6
7 JOINT APPLICATION OF LOUISVILLE GAS)
8 AND ELECTRIC COMPANY AND KENTUCKY)
9 UTILITIES COMPANY FOR CERTIFICATES OF)
10 PUBLIC CONVENIENCE AND NECESSITY FOR)
11 THE CONSTRUCTION OF A COMBINED)
12 CYCLE COMBUSTION TURBINE AT THE)
13 GREEN RIVER GENERATING STATION AND A)
14 SOLAR PHOTOVOLTAIC FACILITY AT THE)
15 E.W. BROWN GENERATING STATION)

Case No. 2014-00002

16
17
18 **PUBLIC COMMENTS OF BIG RIVERS ELECTRIC CORPORATION**
19
20

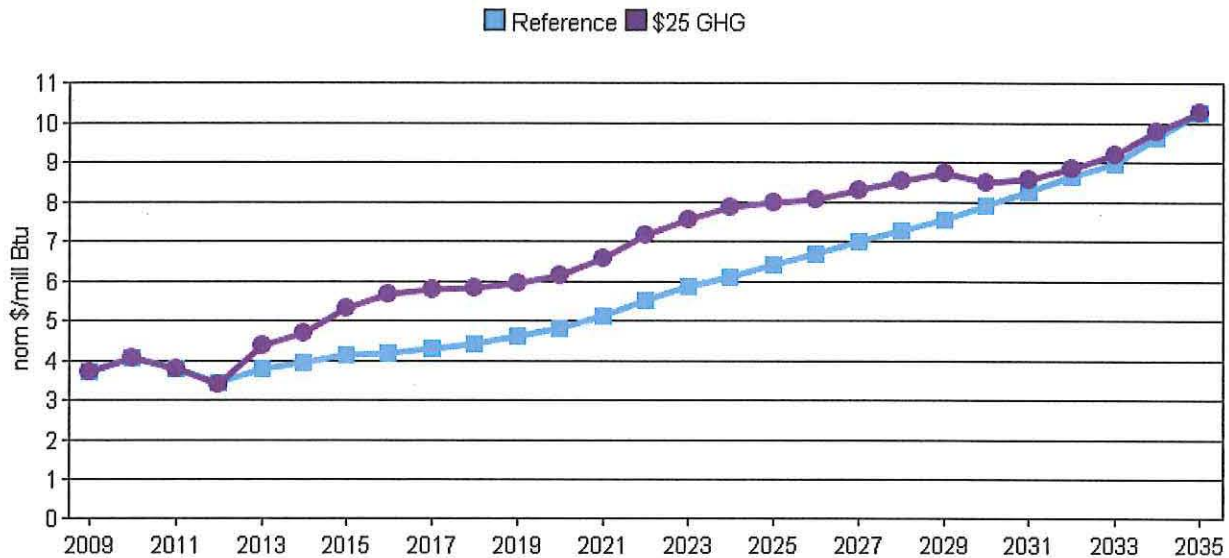
16 This can be illustrated logically by considering the impact of increasing CO₂
17 costs. The carbon policy assumed by the Applicants starts at \$23/ton in 2020 and rises to
18 \$119/ton by 2042. This type of policy would add about \$20/MWh to the dispatch price
19 of coal in 2020 and only about \$8/MWh to the dispatch price of gas combined cycle
20 ("CC"). This effect on CC capacity factors is shown in the Applicants' response to Item
21 34 of the Commission Staff's First Information Request. The response shows that, under
22 all scenarios, the mid carbon policy results in capacity factors above 90% starting in
23 2020. The reason for this is that with the carbon price included in dispatch, the CC is less

1 expensive on a dispatch basis than coal. This pattern of coal vs. gas competition would
2 be replicated in most regions of the country, and this would result in a large increase in
3 natural gas demand, which would lead to an increase in natural gas prices. Thus, natural
4 gas prices at the low level paired with mid carbon is much less likely than natural gas
5 prices at the mid or high levels paired with mid carbon.
